REMEDIATION SYSTEM EVALUATION

FCX-STATESVILLE SUPERFUND SITE STATESVILLE, NORTH CAROLINA

Report of the Remediation System Evaluation,
Site Visit Conducted at the FCX-Statesville Site
20-22 September, 2000

Final Report Submitted to Region 4
March 2002

TITLE:		FCX-OU1 SITE MAP	
LOCATION:		Statesville, Iredell County, NC	
CHECKED:	PR	FIGURE: 1	
DRAFTED:	FM		
FILE:	H016003A.DWG		
DATE:	11-17-00

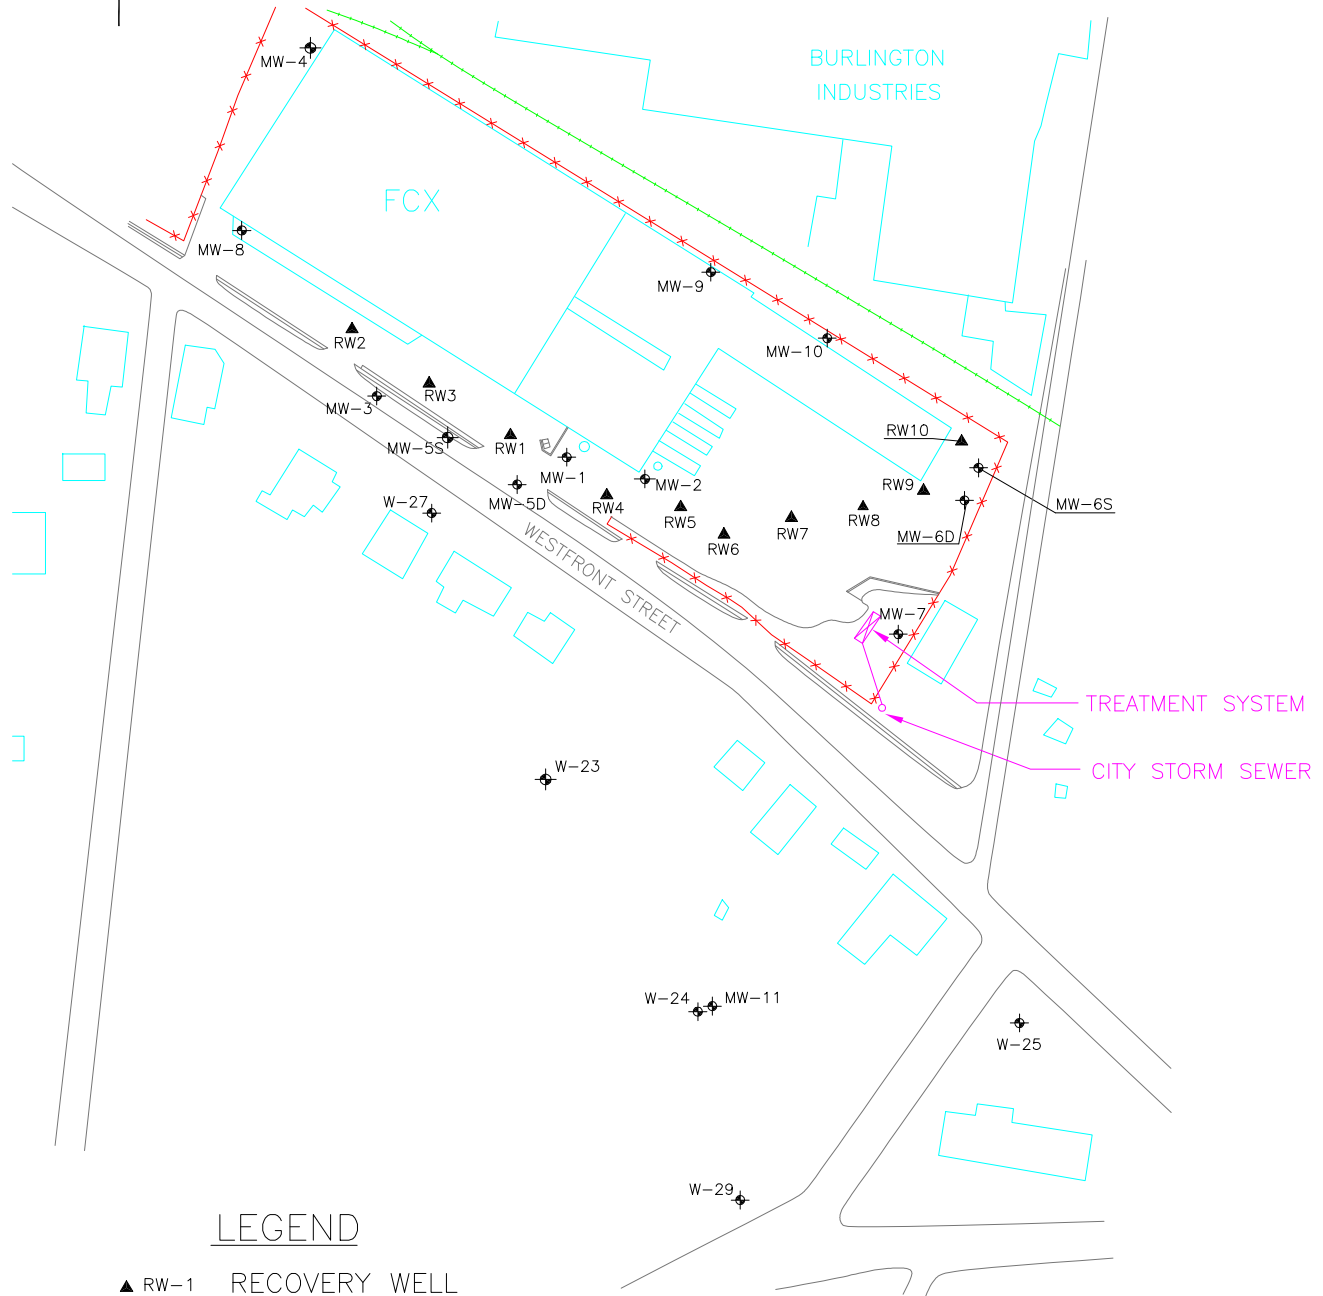
The FCX-Statesville property was an agricultural distribution center that is no longer active. The adjacent property was a textile facility that is also no longer active. USEPA has divided the site into three operable units (see Figure 1):

The site generally slopes to the south. The site is fenced except for the paved loading dock area along West Front Street where four (4) of the ten (10) recovery wells are located (see Figure 1). Approximately one half of the site is covered by the former FCX warehouse. OU2 soil excavation and treatment operations are currently taking place within the warehouse building and on a concrete pad in the northeast corner of the site. The 10 OU1 recovery wells are all onsite running in a line from the southwest to northeast corners of the site on approximately 50 feet centers (see Figure 1). The treatment system is housed in a prefabricated metal structure in the southeast corner of the site. The former Burlington Industries facility is located across railroad tracks immediately north of the FCX property.
